ADDENDUM NUMBER ONE (1)

RE: BID NO. 2015-01 – MINOR REHABILITATION OF SOUTHWEST ELEVATED STORAGE TANK

OWNER: CITY OF EDINBURG

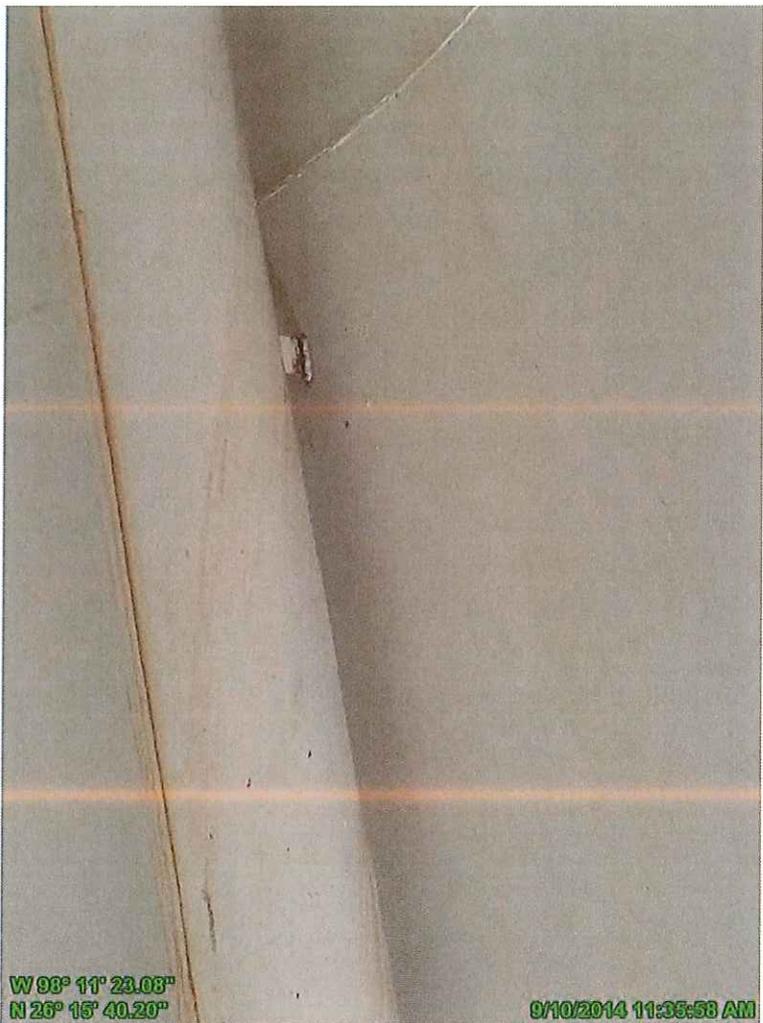
1. Clarification: Section 4, Bid Proposal, bid item 4 shall be amended by adding the following after TANK, **“AND REPAIR STANDOFF ON OVERFLOW PIPE SUPPORT BY WELDING A PIECE OF CARBON STEEL SAME THICKNESS AS EXISTING AND REPAINTING PER SPECIFICATIONS”**
2. Clarification Plan sheet 2: The following picture shall be added as plan sheet 2. Picture 1 is to show bidder the standoff repair which is subsidiary to bid item 4. Picture 2 depicts the amount of corrosion on existing condensate platforms. Typical of 2 platforms. This is subsidiary to bid item 4.
3. Clarification Plan sheet 2: The following picture is to show additional corrosion on the top of the tank to be repaired with bid item 2
